PROPOSED CHRISTMAS FARM, LAND TO THE SOUTH OF LLAY ROAD, CEFN-Y-BEDD, WREXHAM

PLANNING APPLICATION REFERENCE P/2022/0681

**ENCLOSURE 2 – DRAWING NO. 3034-01-D02A: PROPOSED SITE ACCESS
ARRANGEMENTS AND VISIBILITY SPLAYS**

ENCLOSURE 3 - DRAWING NO. 3034-01-ATR01A: SWEPT PATH ANALYSIS

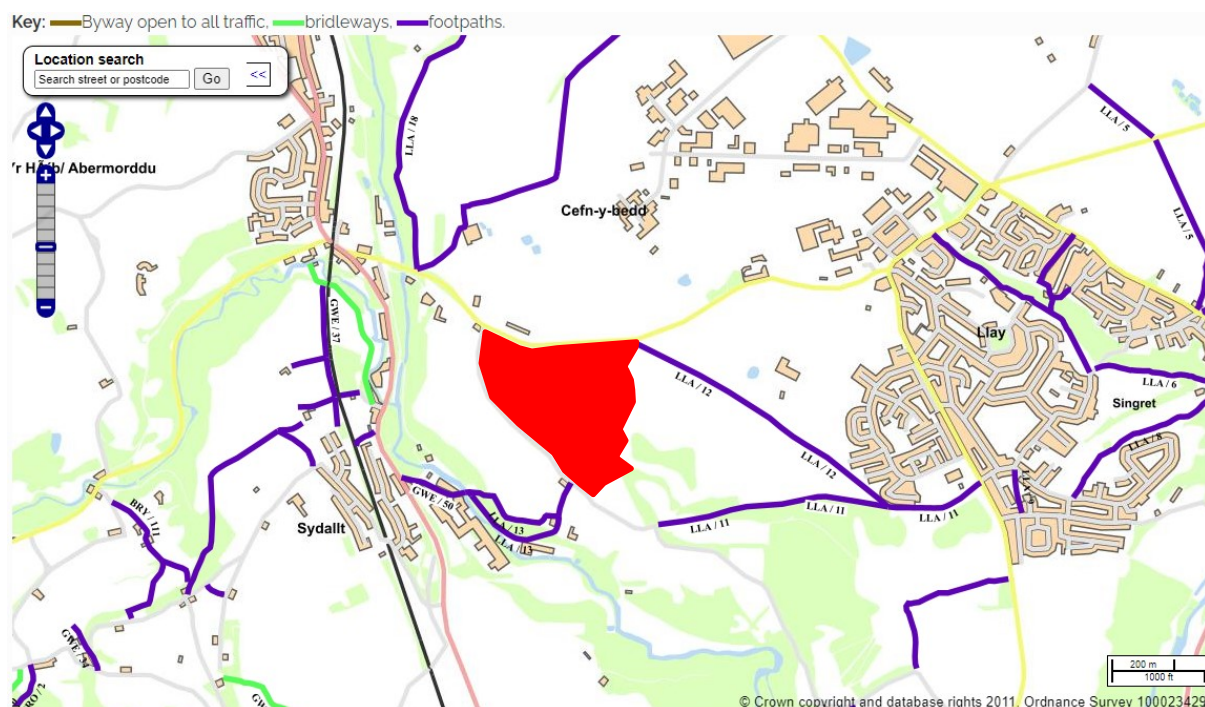
Comment 4: “There would appear to be a number of existing access points located off Park Road to the south of the site. These access points have not been detailed in the application. I would recommend that further details of these access points is provided. It may be considered beneficial to close up any existing vehicular access points serving the site off Park Road.”

From a desktop-based review of the site, site visit video review and additional information provided by the applicant, it is apparent that there is only a single point of access to the application site located off Park Road. This is illustrated below:

The access is informal and disused. It is agreed that this access may be closed-up.

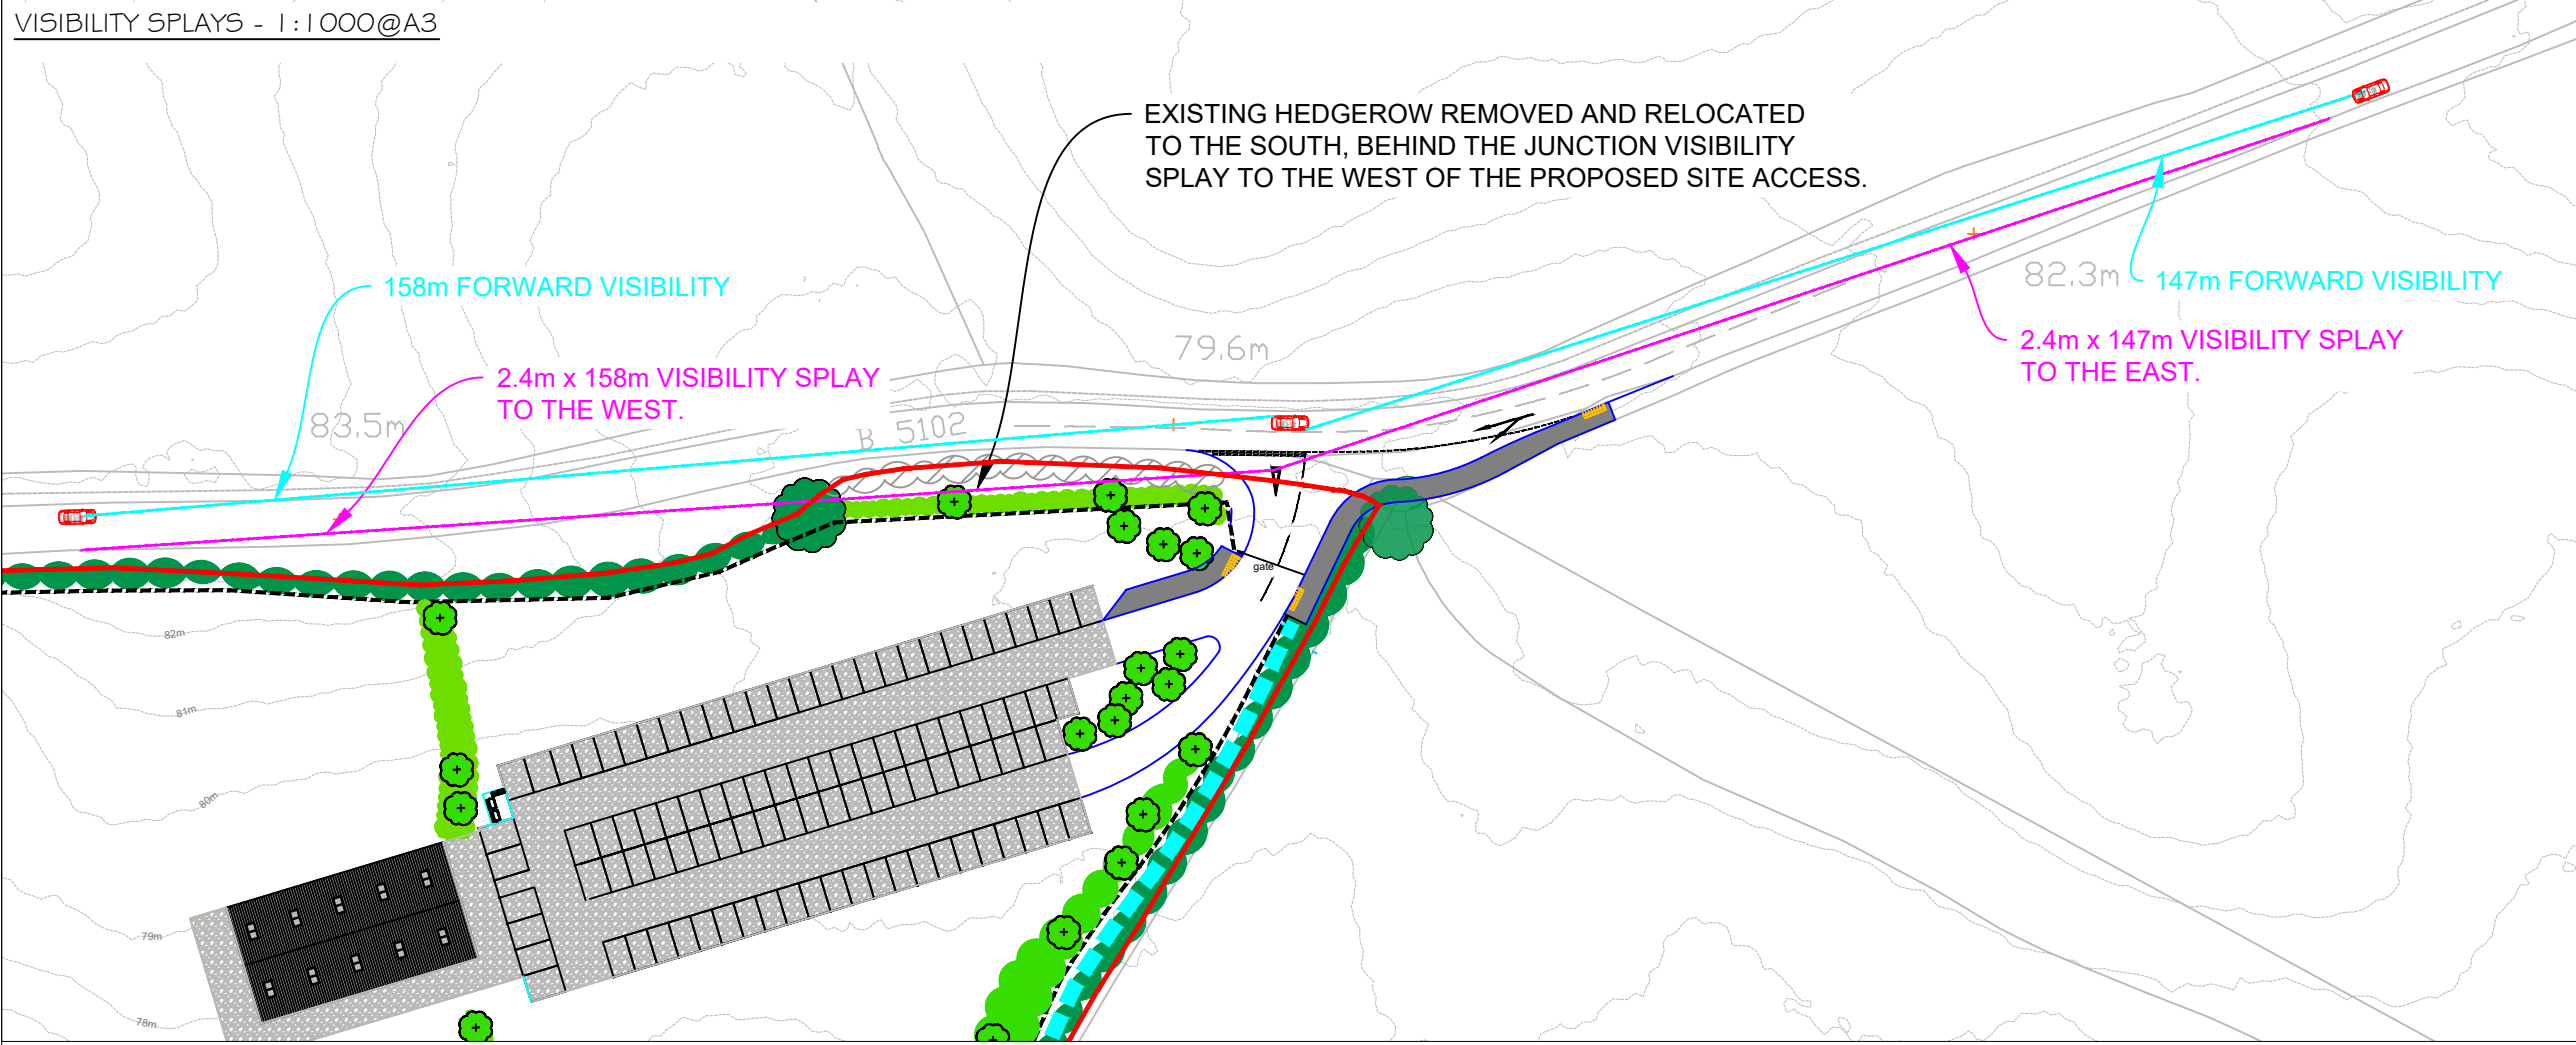
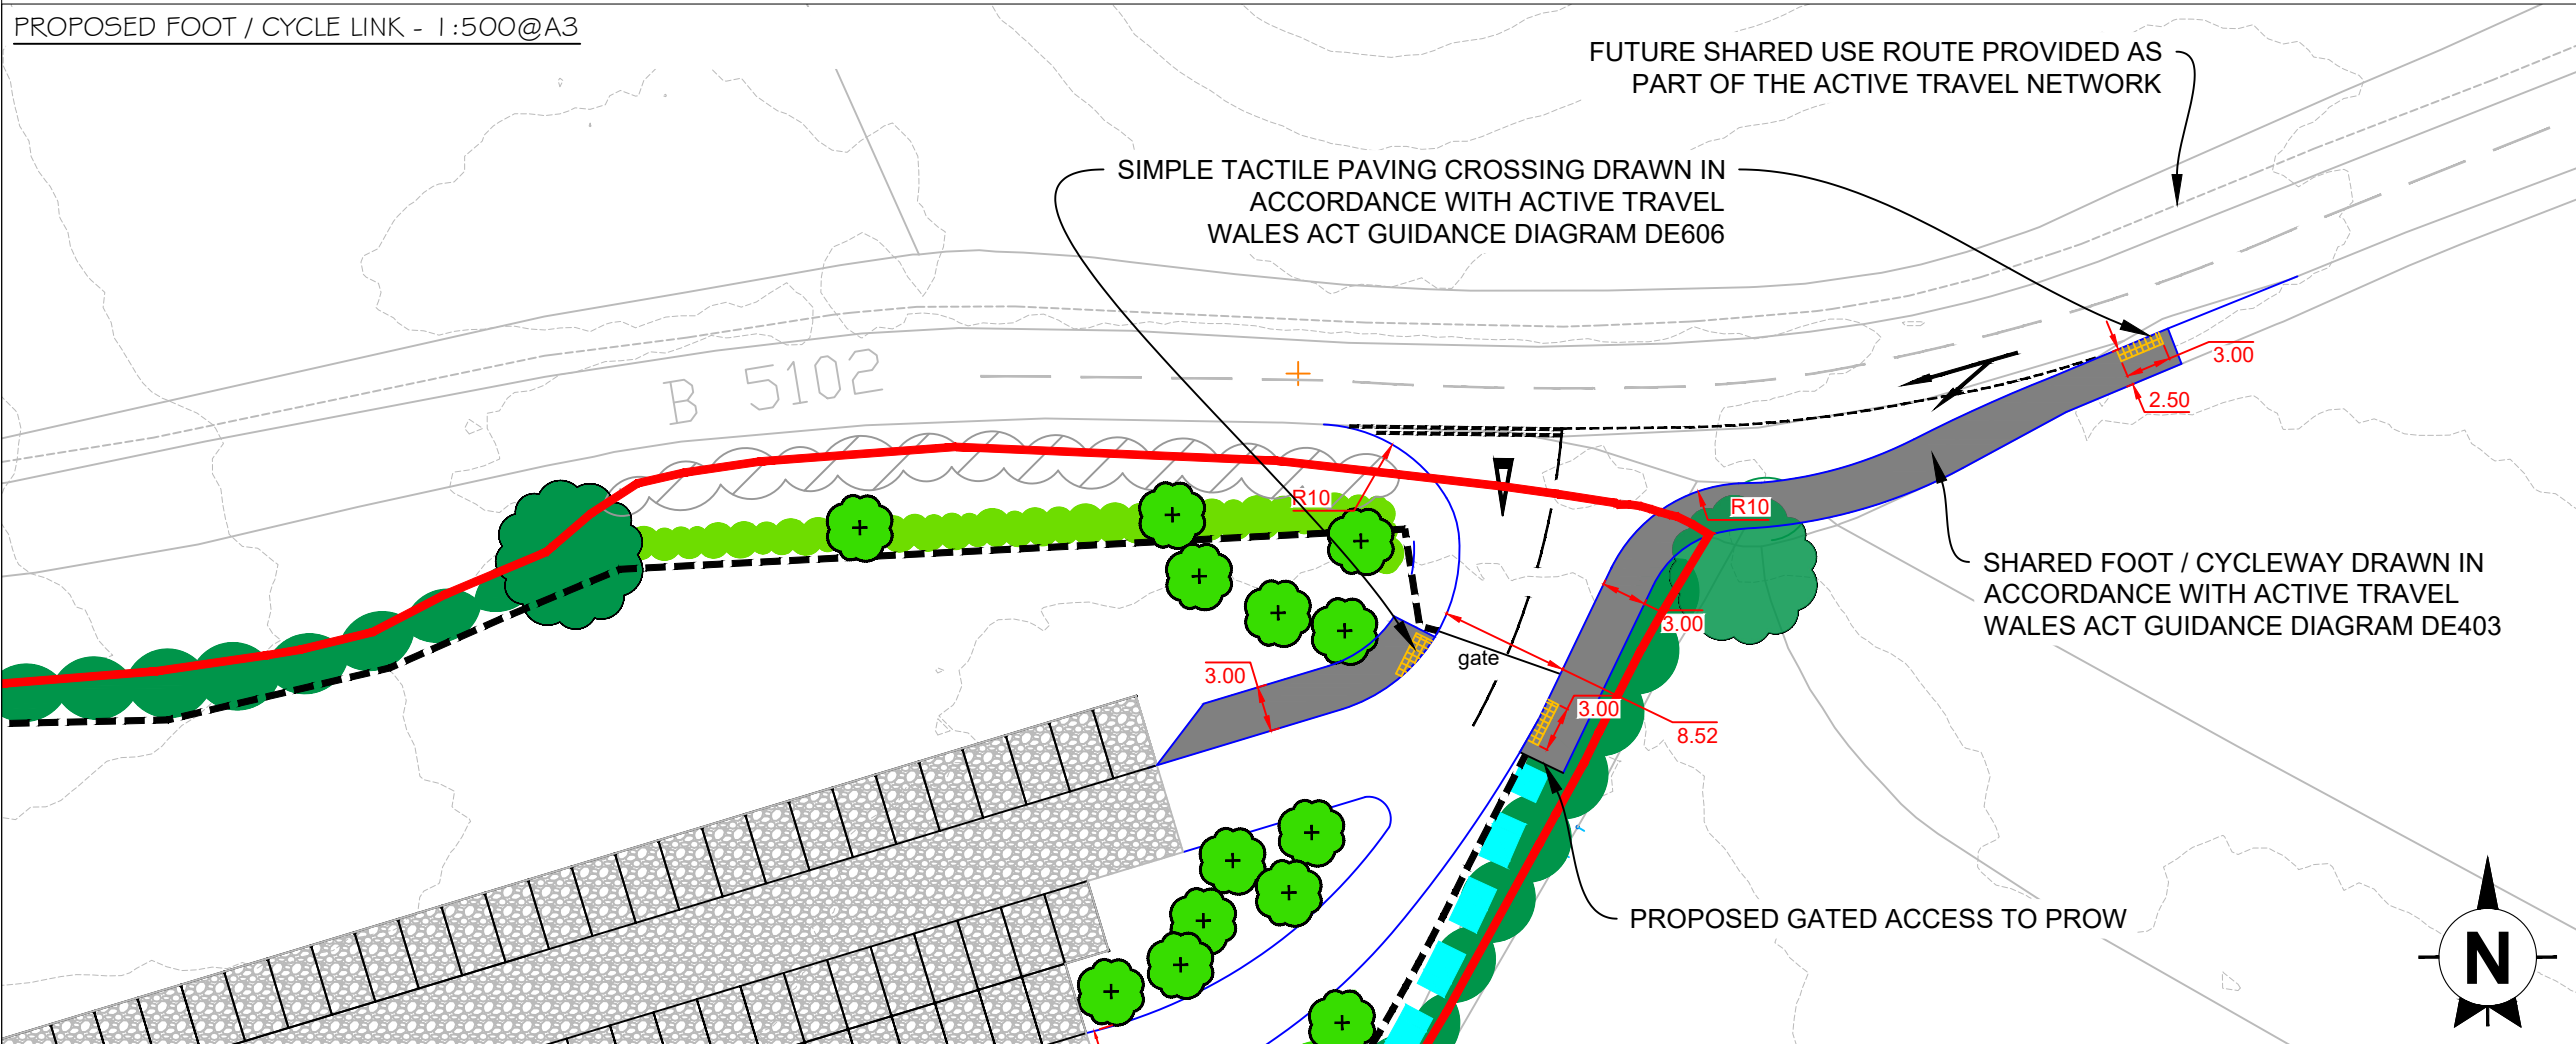
- ***As the footpath terminates at the same point as the entrance/exit to the application site we would require a physical separation (eg. kerbing) for pedestrians from vehicles entering and exiting the site.***
- ***There is currently barb wire alongside the path on the recently erected fencing. We would request that the barb wire is moved from the path side to the field side.***
- ***There is a small water course crossing the footpath to feed some new ponds on the site. We would require this water course to be culverted."***

Comment 2: “Based on speeds of 52.6mph and 50.0mph, any proposed / existing access would normally require visibility splays of 2.4 x 158m and 2.4 x 147m respectively measured to the nearside edge of the adjoining highway. The submitted plans (Drg. No. 3034-01-001 & Drg. No. 3034-01-D01) indicate a proposed splay of 2.4 x 148m in the easterly direction and 2.4 x 161m in the westerly direction measured to the nearside edge. Achieving the required visibility splay in the westerly direction is reliant on the removal / setting back of a significant section of existing hedgerow. Any proposed / existing access in this location would normally need to provide adequate forward visibility in respect of vehicles approaching from the west to vehicles waiting to turn right into the site and forward visibility between vehicles waiting to turn right and those vehicles approaching from the east. This detail should be indicated on a revised layout plan.”

Comment 3: “The existing access is off an existing layby which is in need of re-surfacing. Visibility from the existing access serving Christmas Farm appears adequate in the easterly direction providing a splay in excess of 2.4 x 160m measured to the nearside edge. However, visibility in the westerly direction is inadequate providing a splay of approximately 2.4 x 70m measured to the nearside edge. Visibility is impeded in this direction by the existing hedgerow. The existing access is approximately 3.6m wide and is gated at around 12m behind the adjoining highway. The proposed access indicated on Drg. No. 3034-01-D01 indicates a 7.3m wide access width with 10m radii with any gates being setback at least 15m behind the adjoining highway. I would recommend that such an access incorporates the existing layby to accommodate a slip lane feature if the application is supported. This detail would need to be indicated on a revised layout plan. Such an access would require the applicant to enter into a s.278 agreement with the Council.”

LHA Comment 8: “The submitted Highway Technical Note does not indicate how the site will be served in respect of Active Travel routes or any proposed improvements. I would recommend that the applicant liaises with our Active travel Officer (Tel: 01978 729689) on any potential improvements.”

The revised site access arrangements (**enclosure 2** and **enclosure 3**) include a full height kerb around the entire junction radius and the existing PROW will be gated, set back some way from the proposed site access and behind the proposed foot / cycle link (see comment 8 below). It is therefore considered that there will be sufficient separation between the PROW and vehicles entering and exiting the site.

Drawing No. 3034-01-D02A (enclosure 2) demonstrates that a forward visibility splay of 158m is achievable from a vehicle approaching the site from the west, and a forward visibility splay of 147m is achievable between a vehicle waiting to turn right into the site and a vehicle approaching the site from the east. These splays are commensurate with the interpolated Stopping Sight Distances (SSDs) from the robust design guidance within the Design Manual for Roads and Bridges (DMRB) for the 52.6mph and 50.00mph observed 85th percentile speeds. Sufficient forward visibility will therefore be achievable to allow vehicles to safely navigate into and for vehicles approaching the proposed site access.

In terms of the layby comments, **Drawing No. 3034-01-D02A (enclosure 2)** shows the revised site access arrangement which includes the incorporation of the existing adjacent layby into the site access, as recommended by the LHA. The existing layby will be upgraded and formalised to provide a slip-lane arrangement, allowing vehicles to pull off Llay Road before entering into the site. **Drawing No. 3034-01-ATR01A (enclosure 3)** illustrates that the revised access arrangement will allow vehicles to exit off Llay Road and enter into the site more easily, with additional time to slow on the approach to the access, and additional manoeuvring space within the bellmouth in order for larger vehicles (such as a 11.2m long refuse vehicle) to turn without resulting in any rear end overhang into the adjacent lane. The revised site access arrangement therefore satisfies the above comment. The need to enter into a Section 278 agreement is agreed and the works can also be secured by a suitably worded planning condition.

Following discussions with the Active Travel Officer, the proposed site access arrangements have therefore been amended to take better advantage of the future Active Travel Network infrastructure. The revised access arrangements are shown on **Drawing No. 3034-01-D02A (enclosure 2)**.

The revised site access arrangements include a shared foot / cycleway leading into the site and a tactile paving crossing point integrating the site into the proposed future Active Travel Network infrastructure on the northern side of Llay Road. The proposed foot / cycle infrastructure has been drawn to accord with guidance provided in the Active Travel Act Guidance and particularly Design Element DE403 and DE606 from Appendix G of the guidance for the shared foot / cycleway and the tactile paving crossing points, respectively.
